SUBJECT: Forwards supplemental info requested in NRC 821122 & 29
 telcons re standby shutdown facility. Fire in one fire zone
 will not cause loss of primary inventory.

Subject: Oconee Nuclear Station
Docket Nos. 50-269, -270, -287

OCONEE SER QUESTION 4-ADDENDUM TO OUR ANSWER

ATTACHMENT 1

SSF POWER & CONTROL CABLE ROUTING

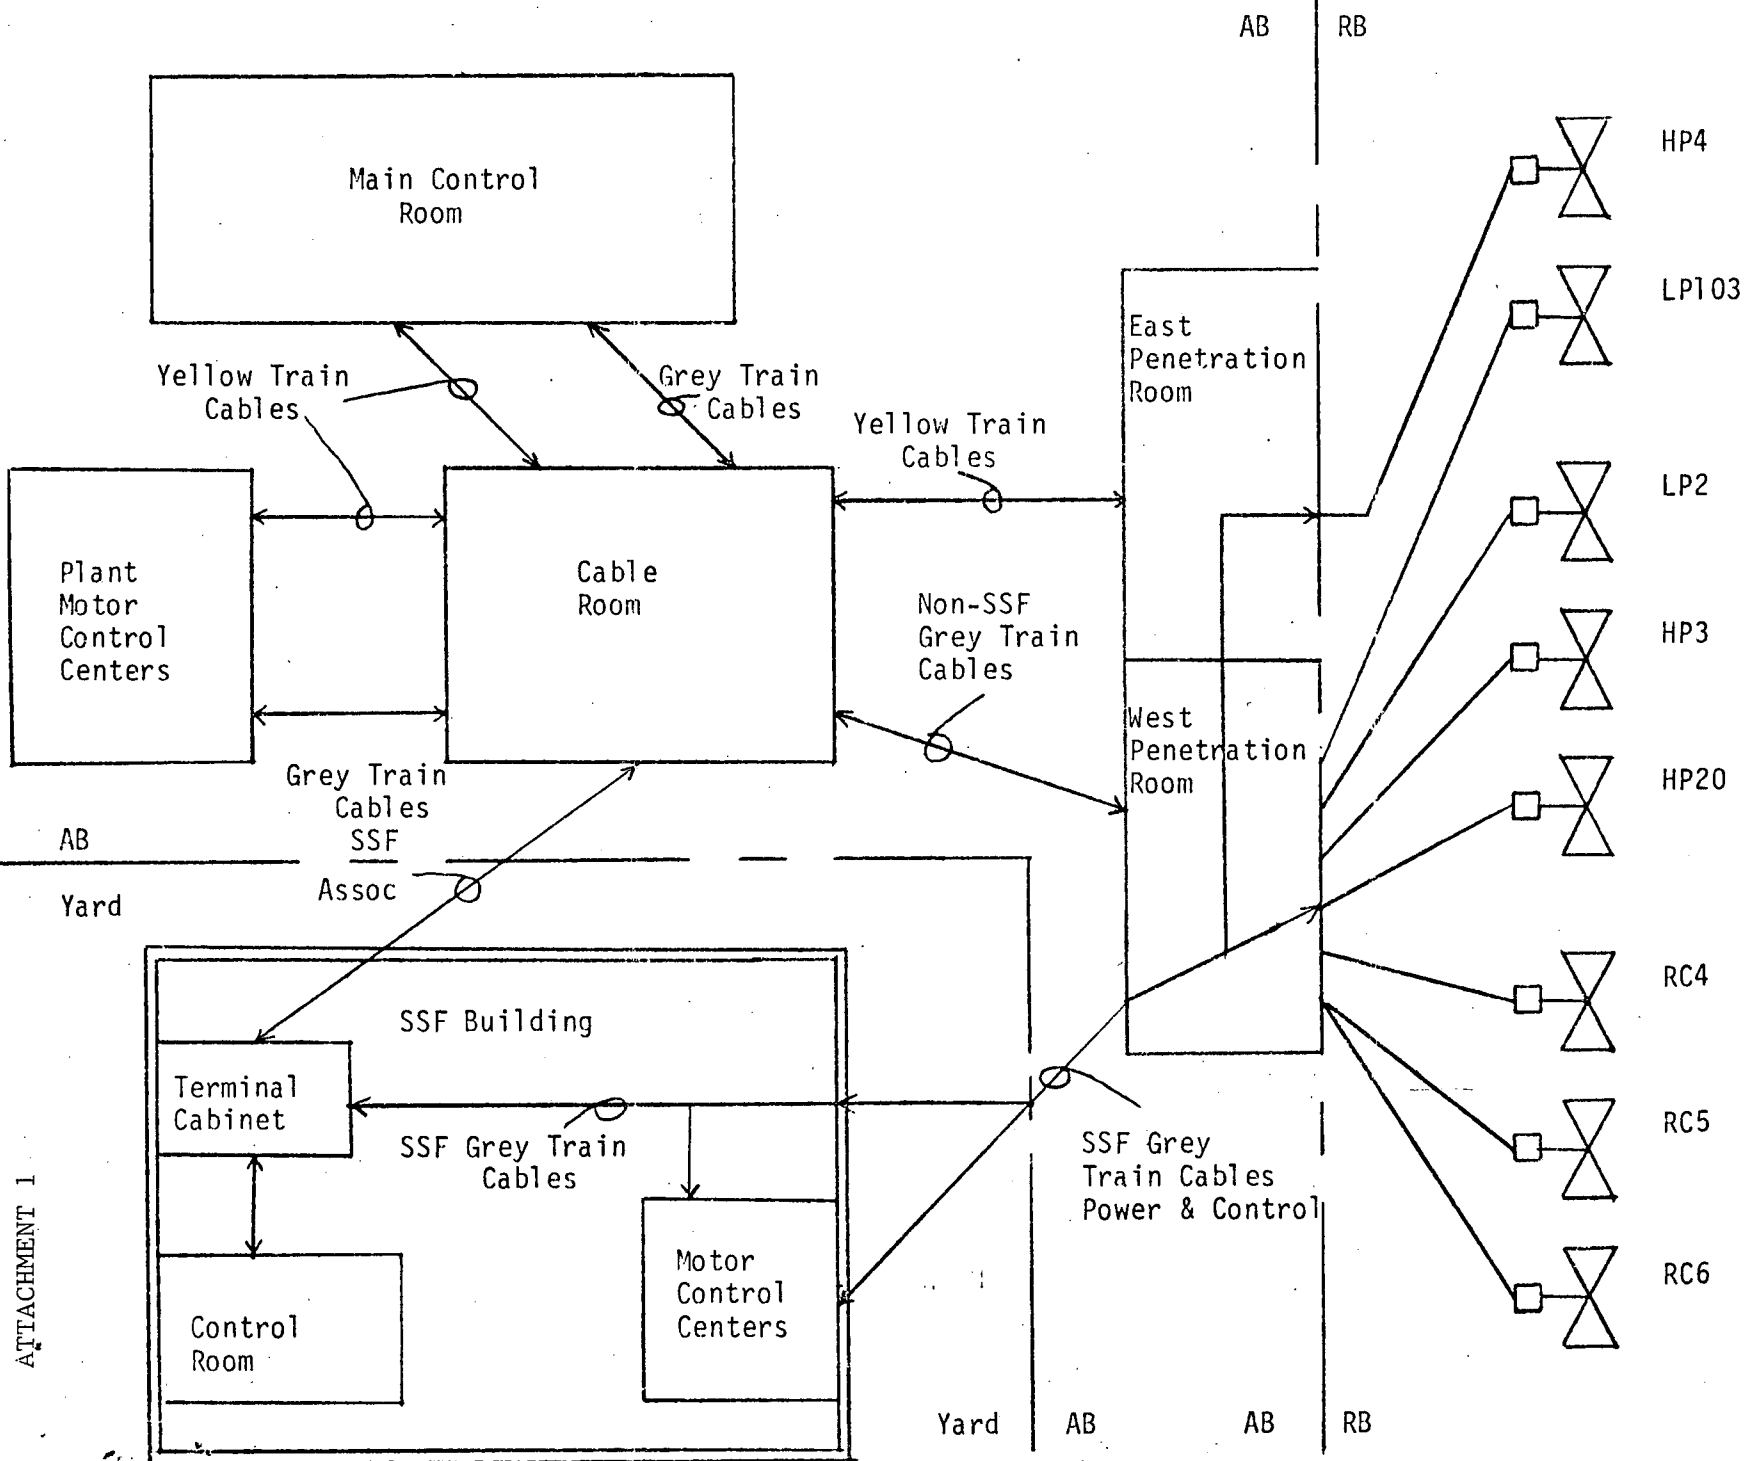
The Motor Control Centers for the primary boundary "Grey train" valves listed in our March 28, 1980 submittal are located in the Standby Shutdown Facility. Control for these valves can be from the Main Control Room during Normal plant operation or from the SSF Control Room during an SSF event. Transfer of the controls between the Main Control Room and the SSF Control Room takes place within the Standby Shutdown Facility. The "Yellow train" redundant valves are powered and controlled from the Main Control Room via the East Penetration Room into containment. Spurious operation due to a fire in any one fire zone can therefore be addressed as follows (Reference attached sketch for cable/fire zone clarification):

A. Valves HP3 (Letdown Cooler "A"), HP4 (Letdown Cooler "B"), HP20 (RCP Seal Return), RC4 (PORV Block), RC5 & RC6 (Press Stm & Wtr Sample), located in containment, receive power and control via cabling in the following manner. Power - from SSF Motor Control Centers via cabling to the West Penetration Room into containment.* Normal power is from the incoming plant 4KV feeder and Emergency power is provided by the SSF Diesel Generator.

a) from the Main Control Room, control is achieved via cabling to the cable room through the cable spreading room to the relay transfer cabinet in the SSF. From the transfer cabinet via the West Penetration Room into Containment.*

b) from the SSF Control Room, control is achieved via cabling to the relay transfer cabinet (this cabinet removes all control from the Main Control Room, transferring control to the SSF Control Room) through the West Penetration Room into containment.*

* HP4 Routes through the West Penetration Room via conduit to the East Penetration Room into Containment.

- B. Valve LP2 (Decay Heat) has its remote starter located in the SSF with a Reactor Coolant System pressure interlock cabled from containment via cabling to the West Penetration Room into the SSF. (Pressure interlock prevents opening of valve LP2 if RCS pressure is greater than 400 psig). Control cabling from the Main Control Room via the Cable Room into the SSF and the cabling for the pressure interlock are in the same fire zone where they become common in the SSF and the West Penetration Room.
- C. Valve LP103 (Alternate Decay Heat) has no Main Control Room controls; control is provided from the SSF Control Room only via cabling to the West Penetration into containment.
- D. The High Point Vent Valves (RC155, 156, 157 & 158), and the Reactor Head Vent Valves (RC159 & 160) have their power removed during normal plant operation or an SSF event.

Conclusion - A fire in any one fire zone will not cause a spurious operation that will cause a loss of primary inventory and disable the system necessary to provide makeup.
